MAYOR & COUNCIL COMMUNICATION

AGENDA ITEM: Village Preserve Residential Subdivision - Preliminary Plat

PLANNING COMMISSION
DATE: 9/8/14
AGENDA ITEM: 4A – PUBLIC HEARING ITEM
CASE # 2014-43

LP1 / LP4

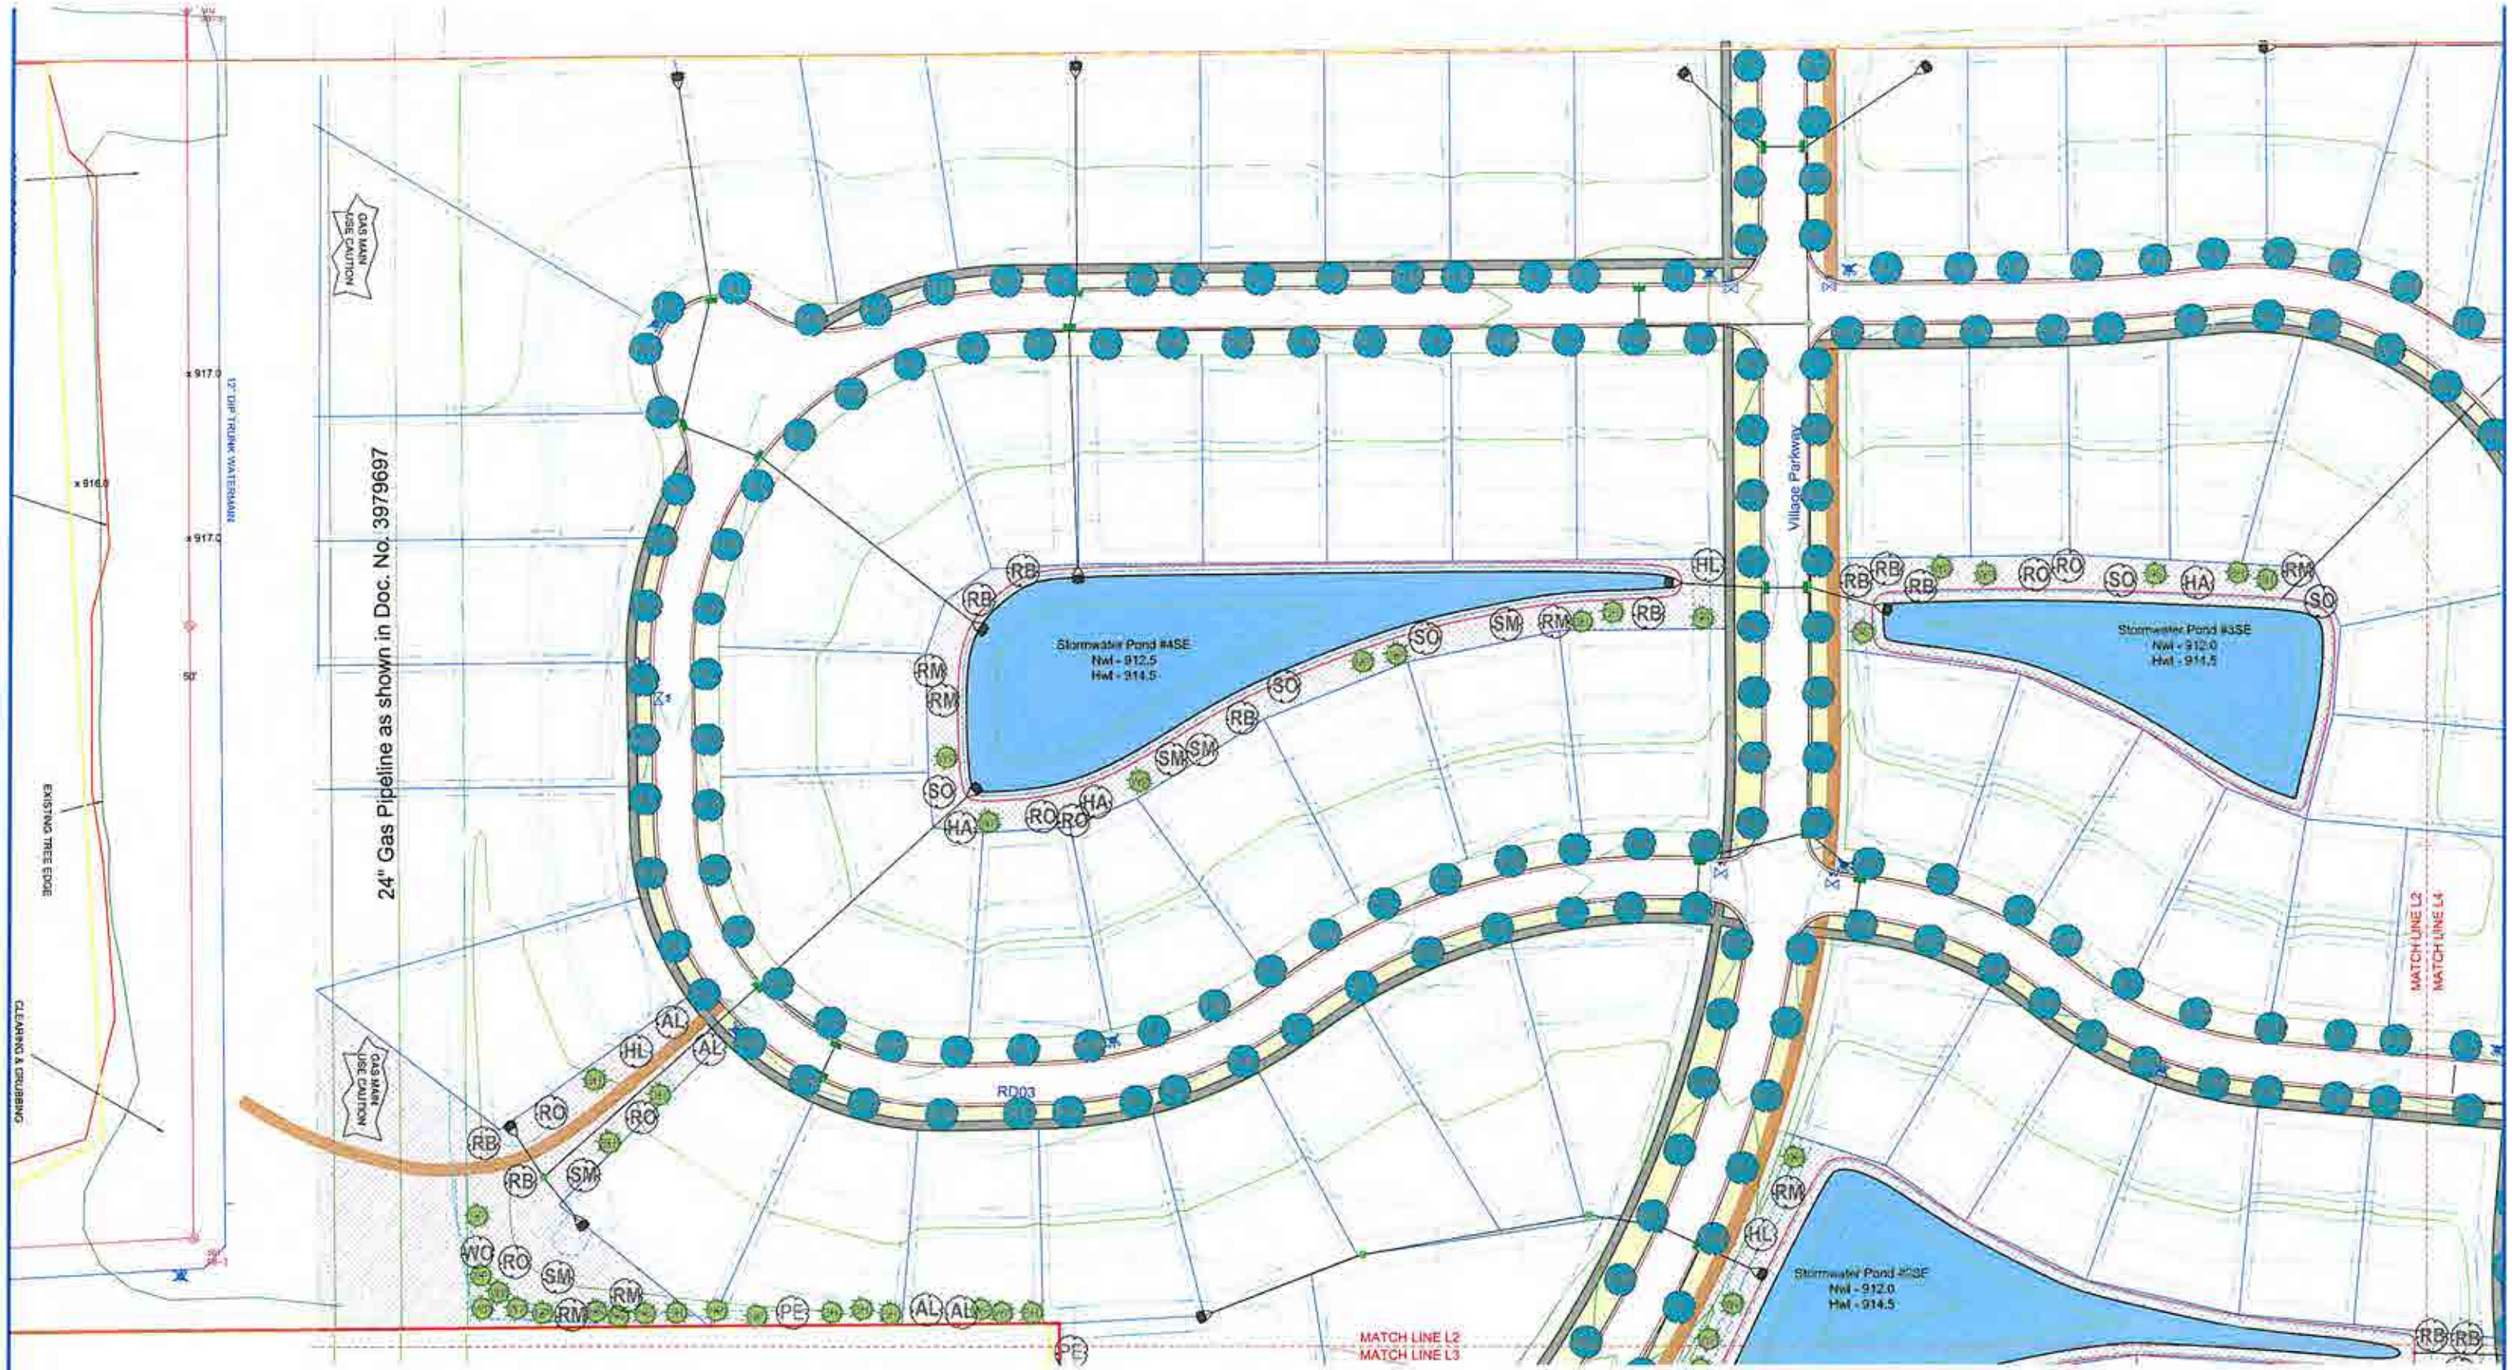
1. Provide your calculations for street frontage trees on sheet LP1.
2. Please represent planting areas within centers of Cul-de-sacs.
3. Provide temporary and permanent groundcover vegetation utilizing 100% native landscape plants for all lots, commonly held HOA & City R.O.W. areas with the exception of the areas noted to be sodded, irrigated and managed as traditional turf bed areas. Suggested native cover for proposed home lots could be Little Bluestem with the addition of some (10+ species) native wildflowers depending on aesthetic look desired (all blue flowers, mix of flowering times, etc…). Suggested permanent native cover should provide the most appropriate ecologically correct mixes. A suggested example would be to reference the seed mixes offered by MN Native Landscapes (http://www.mnnativelandscapes.com/). Please provide the appropriate mix for each specific proposed landscape situation. For example the short dry upland mix for a non-irrigated upland outlot area where shorter grasses are desired adjacent to paths or streets.
